Responses to reviews for manuscript **Global Evaluation of the Ecosystem Demography Model (ED v3.0)**

To Reviewer #2:

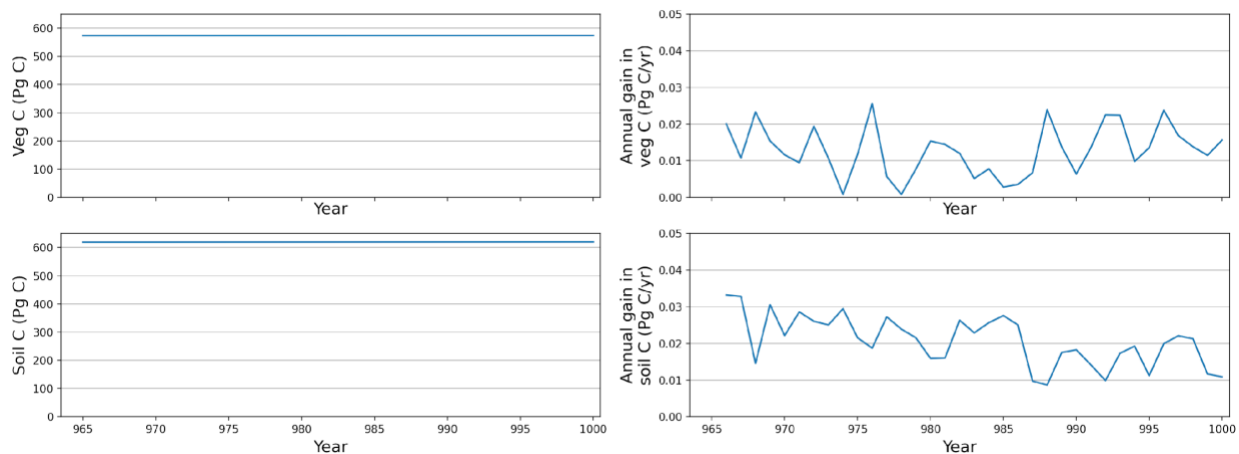
L165: Are 1000 years enough to obtain a real equilibrium state in your model? Considering that ED model is DGVM and that the time evolution of vegetation distribution and land carbon amount depend on each other, I would have expected more than a few thousand years are required to obtain a real carbon equilibrium. If not perfectly equilibrated, it may be one of the reasons of your model to make relatively lower amount of global SOC.

Response: Very good point and we agree that some ESMs/DGVMs need to spin up for thousands of years in order to reach equilibrium in carbon pools. Here we add a figure of vegetation and soil carbon of equilibrium run of ED v3.0. The left two panels are total carbon in vegetation and soil pools over the last 36 years, and the right panels are respective annual changes. The figure indicates the vegetation and soil carbon are near equilibrium within the 1000 years of spin-up.

In terms of low global SOC, we think it is primarily due to the rapid turnover rate of SOC which could also shorten the time required to reach equilibrium for SOC.
